November 28, 2011

TO: Other Houghton Community Council members and Planning Commission

RE: Height Regulation Exemptions for Solar Panel installation (KZC115.60.2.a.4)

SIDE TO SIDE INSTALLATION -
SOLID VISUAL BARRIER

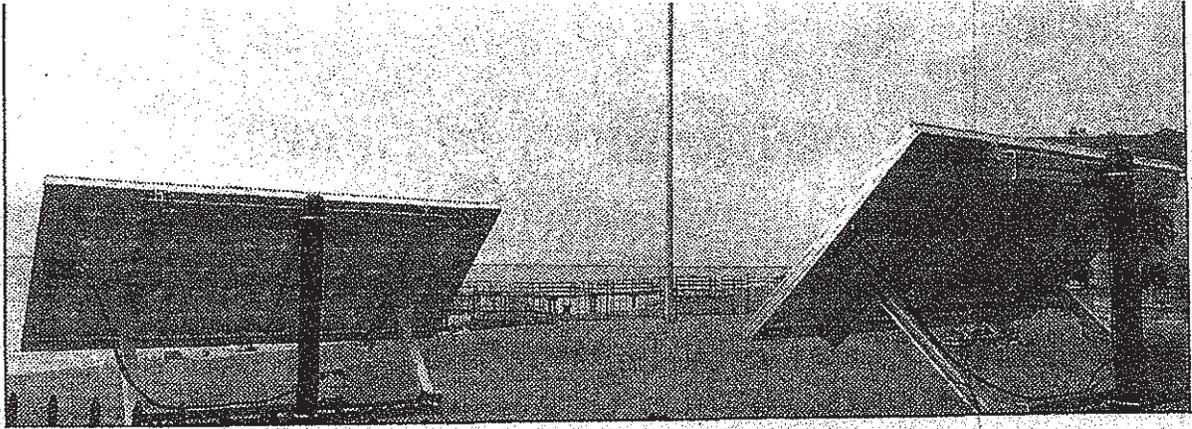
Allowing a 20" Height Exemption on flat roofed structures as an incentive for installation of Solar Panels is excessive in Single-family and Multi-family Zones in the City.....especially when current technology has a system with a LOW profile of 8.37" (see attached materials regarding Sunpower's T5 Solar Roof Tile system and the 'Solar Panel Efficiency' from IBOG.org). The T5 system has an efficiency @ 19% most other solar panel systems are @ 11 – 15% efficiency. Conventional "tilt-racking" solar systems are far more intrusive into space and create more 'visual pollution' from the back side than the low-profile T5 solar tile system designed for area- and weight-constrained spaces). Waiting until an installation creates a situation that causes neighbors to complain about losing value of their home is too late. Isn't it better to require technology be used that is least intrusive and available now.

The last 2 pages of my handout show a side-by-side installation that creates a solid visual barrier, and photos from a Seattle Times article from October 30, 2011 that illustrates the "un-intended" consequences of installing solar panels on a homeowner's roof (which HE doesn't see, but which his neighbors would) and his pier (which he sees from his home).....and I ask "would Kirkland think this was "consideration" for the neighbors.

- Single-family Zones – limit to Best ‘current’ technology or 8.37” (as of 2011)
- Multi-family Zones – limit to no higher than the height of the parapet of the structure
- Industrial or Commercial Zones – limit to 20”
